## ILLUSTRATED PARTS LIST

PTO REAR (816)

Model Number Effective Date Form Number 19134E1 12-1-74 20935L1

This writing is a correction for:

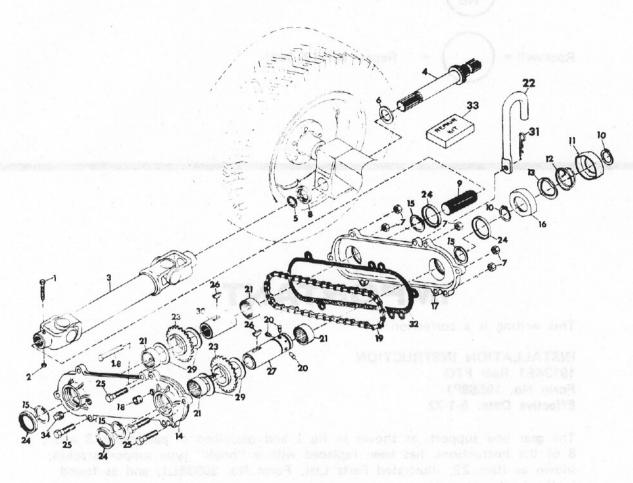
The gear box support, as shown in fig 1 and described in paragraphs 3 and 8 of the instructions, has been replaced with a "hook" type support-bracket; shown as Item 22, Illustrated Parts List, Form No. 20935L1, and as found in the hardware pack.

Replace paragraph 3 of the instructions with the following procedure.

3. Hook the support-bracket over the clutch cross-shaft of The Gravely. Position it between the spring-clamp assembly and the frame. Have the short end towards the rear as shown by the Illustrated Parts List.

Disregard paragraph 8. The "hook" must be removed when the gear box is removed after use.
